DECISION OF THE PLANNING COMMISSION

CLASS 3 DESIGN REVIEW / CONDITIONAL USE / CLASS 3 SITE PLAN REVIEW / CLASS 2 ZONING ADJUSTMENT / CLASS 2 DRIVEWAY APPROACH PERMIT; CASE NO. DR-CU-SPR-ADJ-DAP18-06

Summary: A request for a Design Review, Conditional Use Permit, Site Plan Review, Class 2 Zoning Adjustment and Class 2 Driveway Approach Permit to allow a 20-unit multi-family use on the subject property.

LOCATION: 3355 Portland Road NE, Salem, OR 97301

PROPOSED NEW DEVELOPMENT PLAN

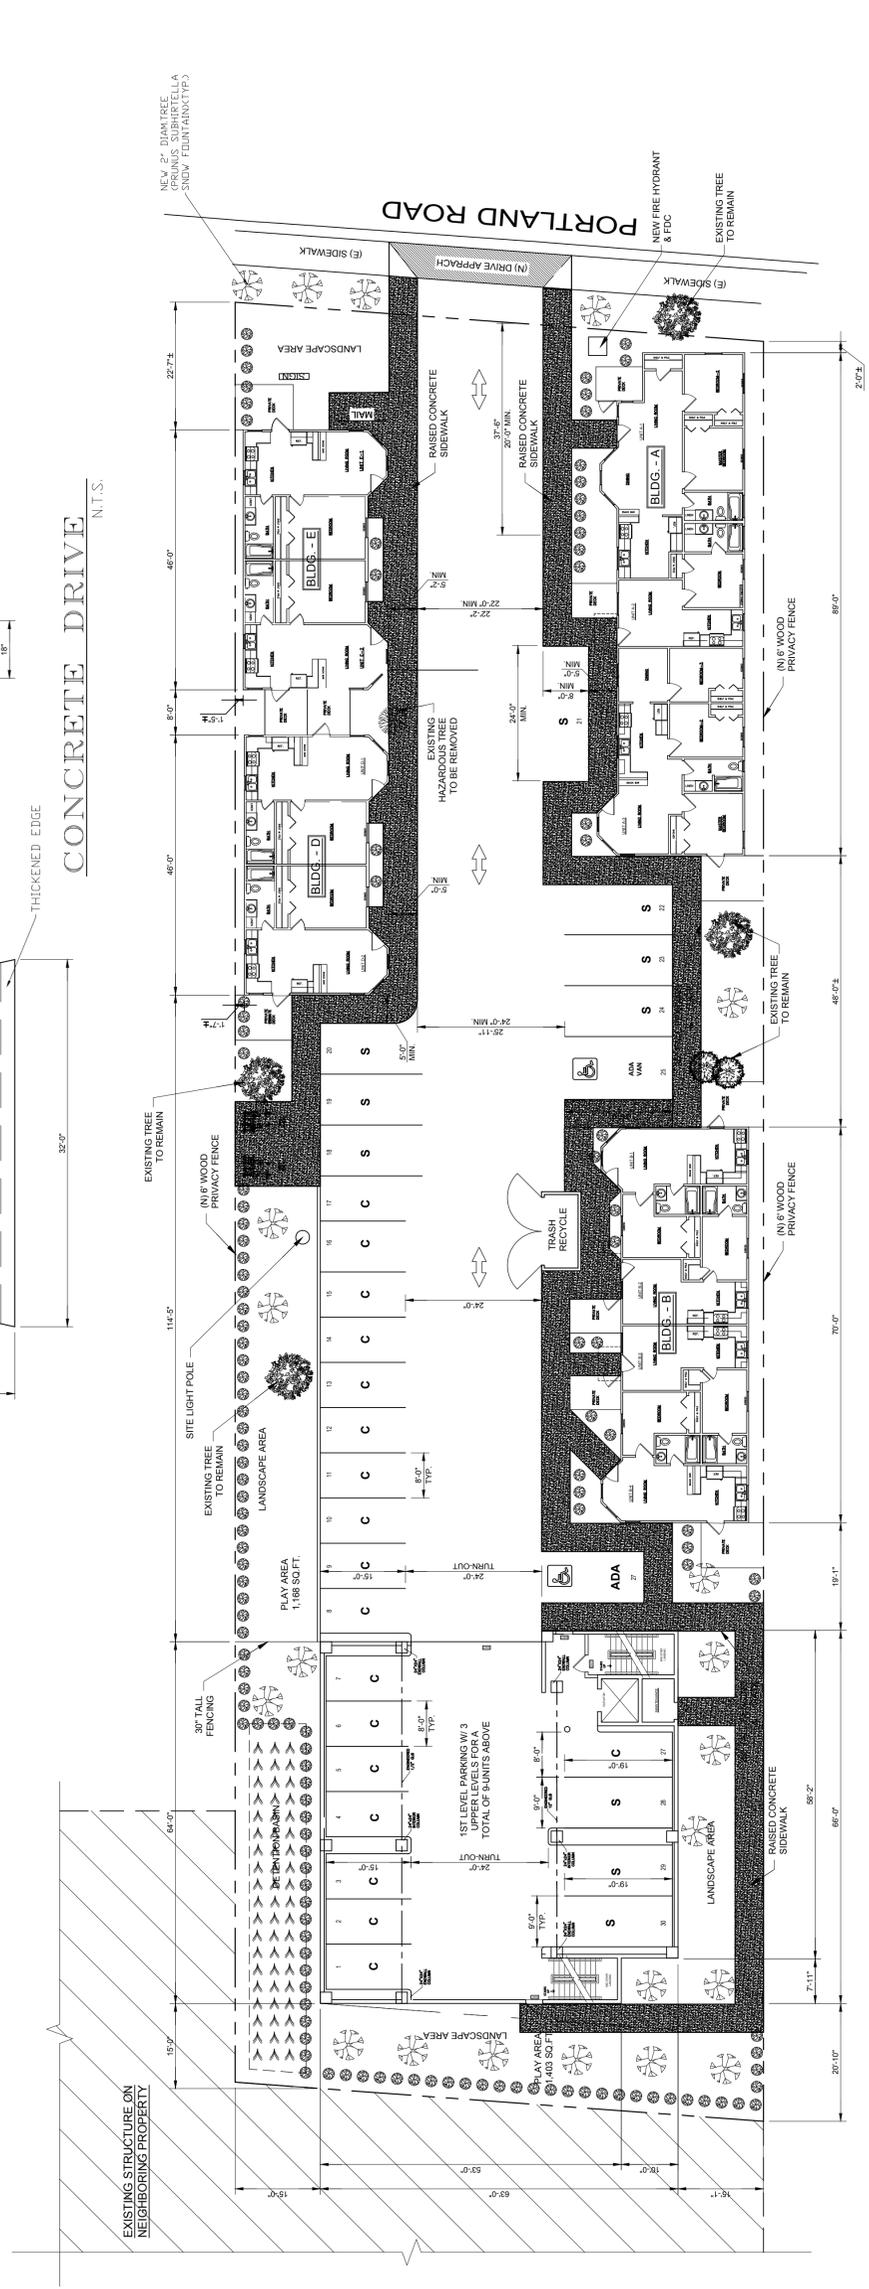
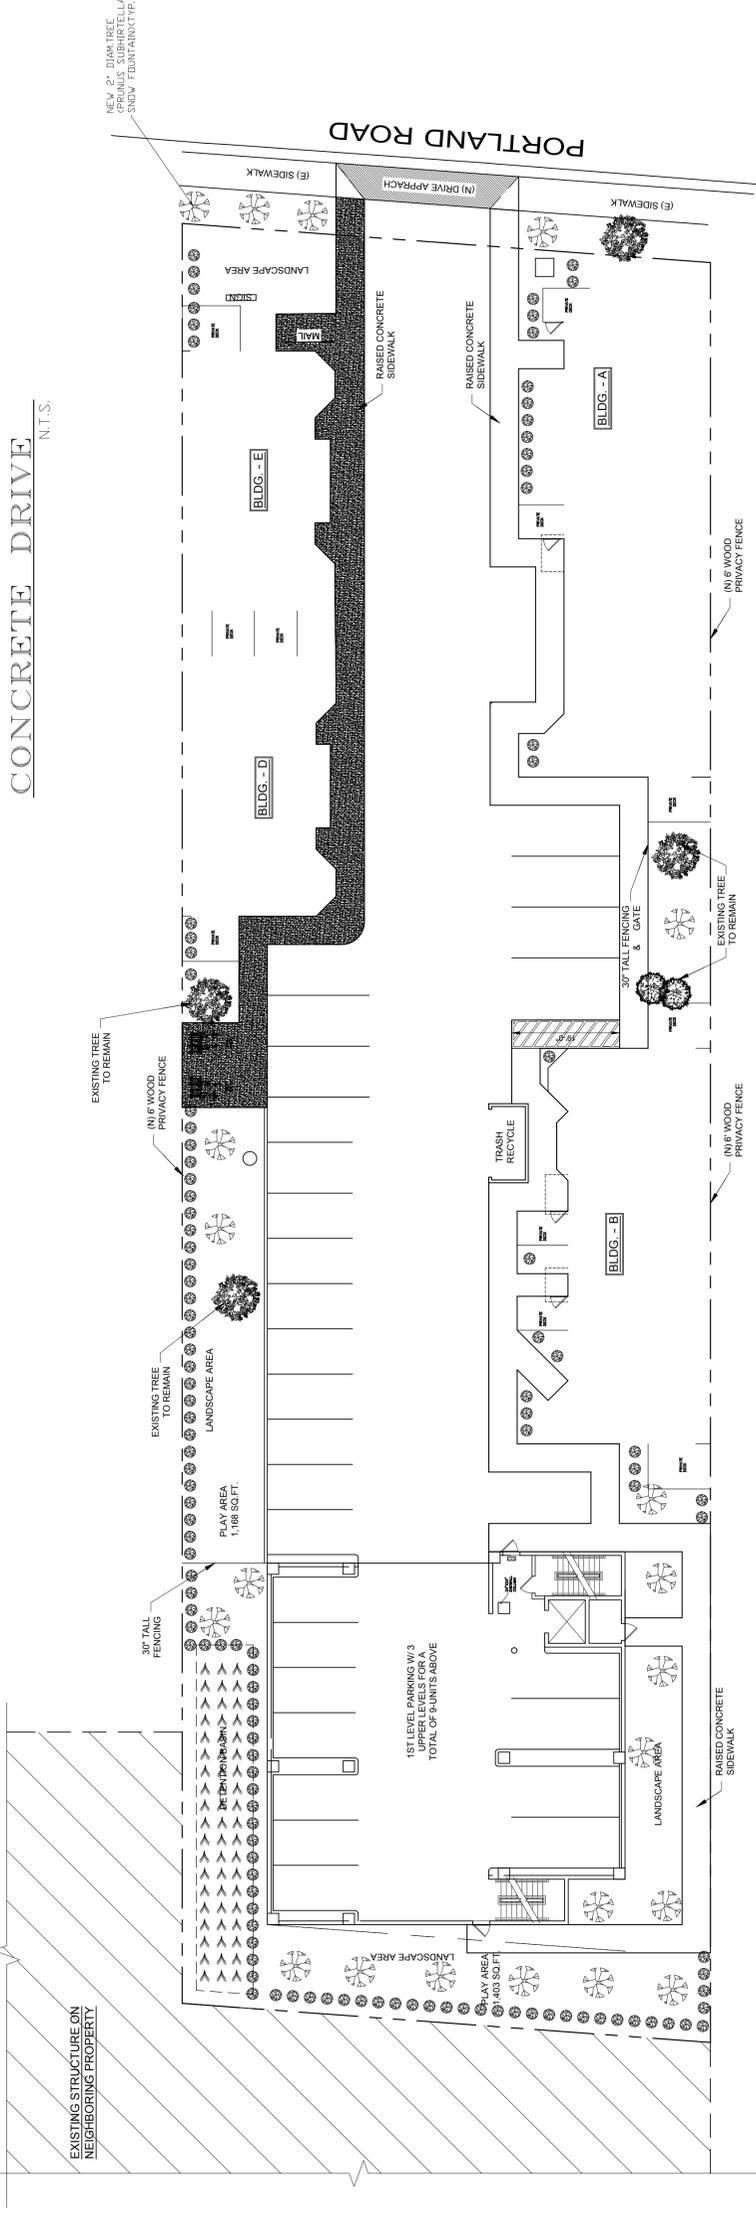
- Condition 4:** Along all property lines, except abutting Portland Road, installation of an ~~8-foot~~ 6-foot solid site obscuring fence.
- Condition 5:** The multi-family use shall contain no more than 20-dwelling units.

Finding: The proposed vehicle use area and the new proposed building is 15-feet from the north property line. The site plan indicates that the setback area will include a 6-foot-tall sight obscuring fence and Type C landscaping.

Finding: The proposed building and vehicle use area are setback from this property line by approximately 15 feet. The site plan indicates that the setback area will include a 8-foot-tall sight obscuring fence and Type C landscaping.

Finding: The proposed building and vehicle use area are setback from this property line by approximately 15 feet. The site plan indicates that the setback area will include a 8-foot-tall sight obscuring fence and Type C landscaping.

Finding: The subject property is approximately 0.66 acres in size (28,750 square feet), requiring a minimum of 4,313 square feet of landscape area ($28,750 \times 0.15 = 4,312.5$). The site plan indicates that 5,446 square feet of landscape area will be provided.

Finding: The proposed site plan indicates a parking garage and surface parking area. The parking garage is exempt from interior landscaping standards. The parking and driveway area is 5,800 square feet in size. A minimum of 290 square feet of interior parking lot landscaping is required ($5,800 \times 0.05 = 290$). Although the site plan does not indicate the amount of interior parking lot landscaping provided, it appears to exceed the minimum standard.

Finding: The parking and driveway area is 5,800 square feet in size. A minimum of 290 square feet of interior parking lot landscaping is required ($5,800 \times 0.07 = 406$). Although the site plan does not indicate the amount of interior parking lot landscaping provided, it appears 450 square feet is being provided and will meet this standard.

LANDSCAPE PLAN

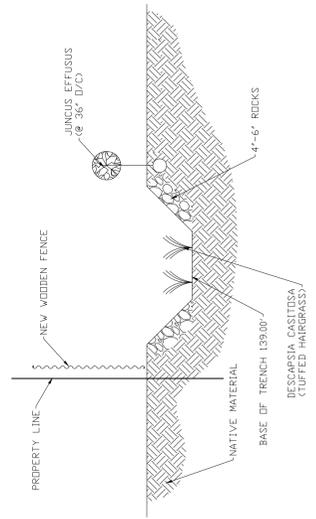
Finding: The preliminary landscaping plan shows street trees to be planted within the public right-of-way approximately every 40 feet.

Finding: The applicant's written statement indicates that one plant unit will be provided for every 20 square feet of landscaping and at least 40 percent of the plant units will be trees. The preliminary landscape plan indicates that 23% of the site will be landscaped.

Finding: The applicant provided a landscaping plan which indicates 17 trees will be planted on site within the landscaping areas. The proposed landscaping areas abut Portland Road NE and provided a buffer to the off-street parking areas. Therefore, this criterion has been met.

Finding: The applicant does not indicate that they will be providing a landscaping and irrigation plan designed by an Oregon landscaping architect.

- Condition 6:** All trash/recycling areas shall conform to the solid waste service area standards of SRC 800.055.
- Condition 7:** The applicant, at building permit, shall provide a landscaping and irrigation plan designed by an Oregon landscaping architect.

BLDG. - A
FRONT ELEVATION

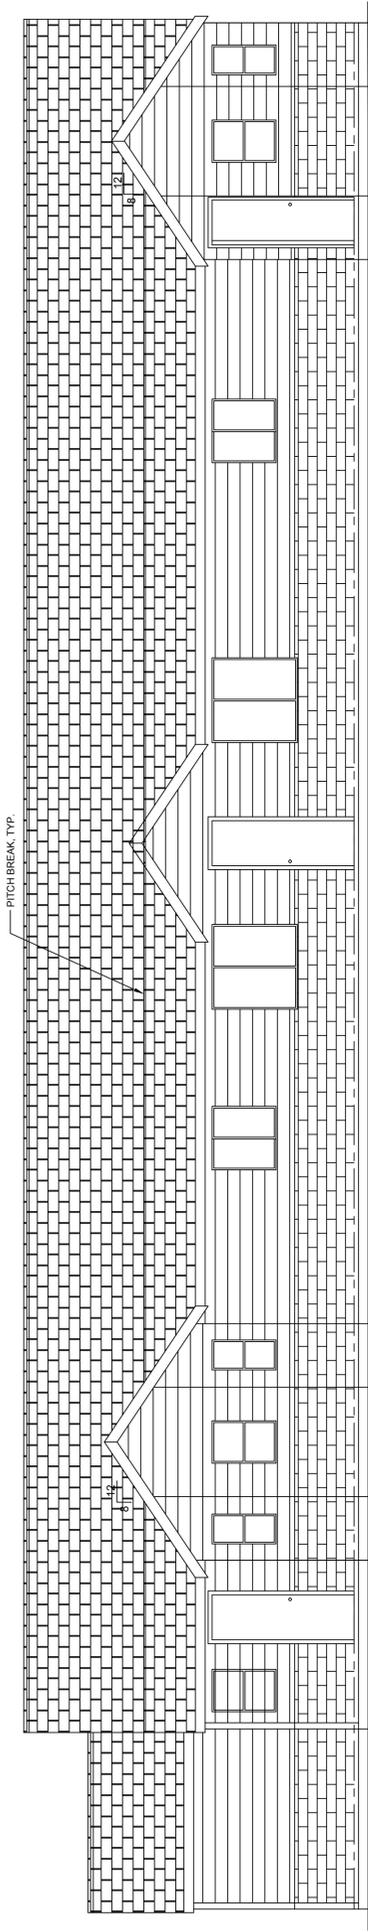
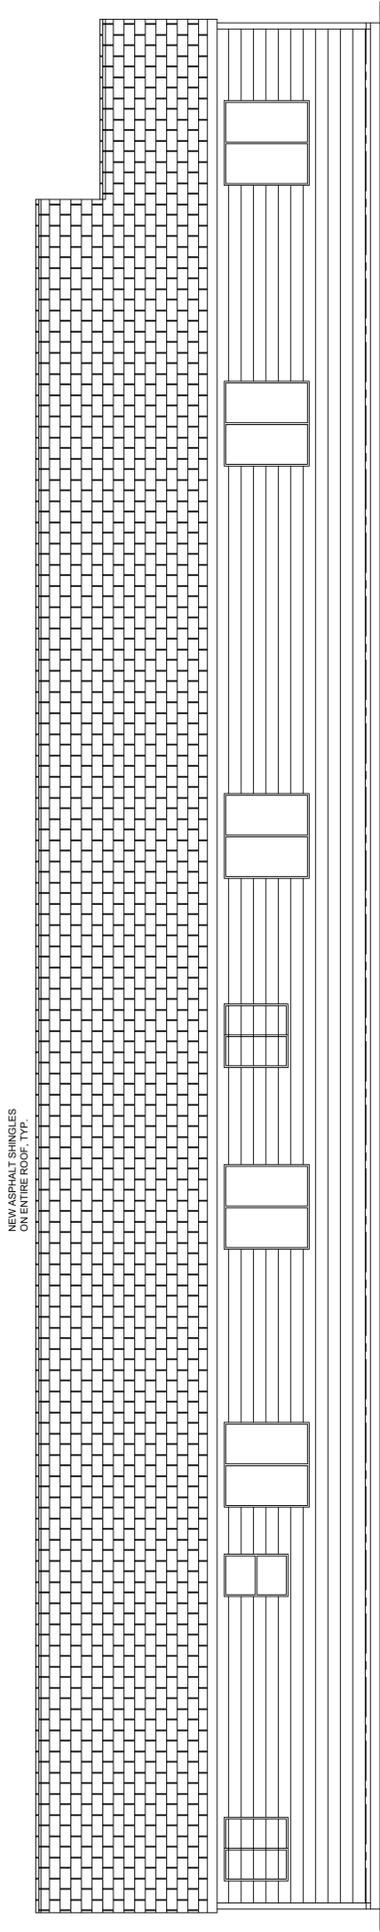
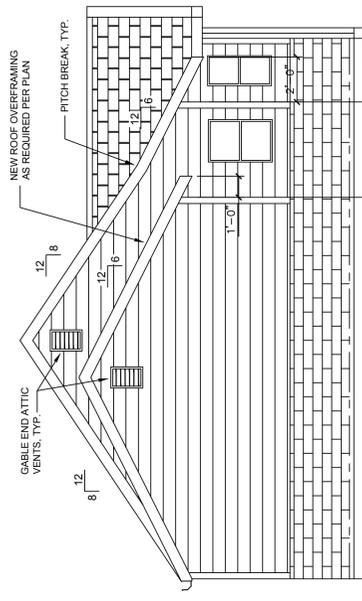
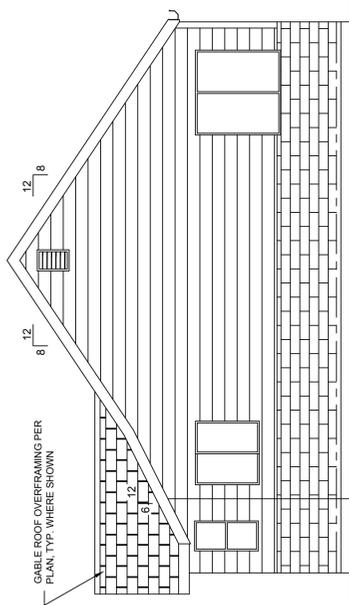
- Condition 1:** The proposed building shall be provide contrast and distinction between the ground floor and upper floor facades by incorporating one or more of the following:
- a) Vertically oriented lap siding, or horizontally oriented lap siding that is wider than that provided on the upper floor facades, that is painted a different color than the upper floor facades; or
 - b) A siding material different from that used in the other portions of the building facades.

Finding: The proposed three story building provides offsets, varied roof elevations and contrasting facade materials are provided in the design for each building. The existing structures provide offsets on each end of the buildings and proposed varied roof elevations.

Condition 2: The proposed building shall provide contrast and distinction between the ground floor and upper floor facades by incorporating one or more of the following:

TRASH ENCLOSURE
ELEVATIONS

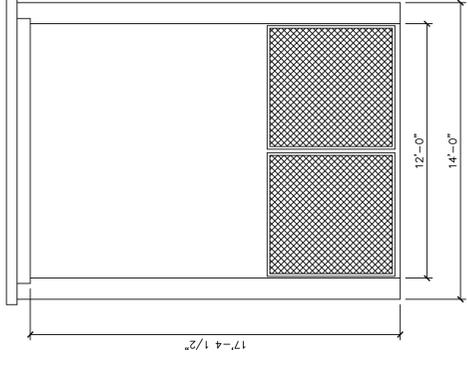
Finding: The site plan includes a trash and recycling areas to serve residents. The proposed site plan does not indicate details of the recycling and solid waste receptacle area. Therefore, as conditioned below, the applicant shall,

Finding: The site plan includes a trash and recycling areas to serve residents. The proposed site plan does not indicate details of the recycling and solid waste receptacle area. As conditioned below the proposed enclosure will meet the solid waste service area requirements of SRC Chapter 800.055, including requirements for vehicle operation and servicing area. Adequate space is provided to allow for the servicing of recyclables.

- Condition 2:** The recycling area shall be similar materials and design as the proposed development.
- Condition 3:** The applicant shall incorporate a disclaimer into their tenant lease agreements that excessive noise is possible based on surrounding uses.
